| <b>Date Issued :</b>  | July 02, 2024   | <b>PCN Number :</b> | 515293 |
| <b>Reason for Change :</b>  | Packaging Method/Quantity Changing  |                     |        |

Before Picture

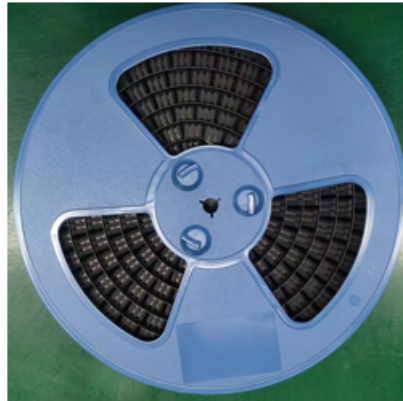
- Change packing tape reel from paper trays to plastic trays

- Change packing tape reel from paper trays to plastic trays for enhance packaging protect capabilities.
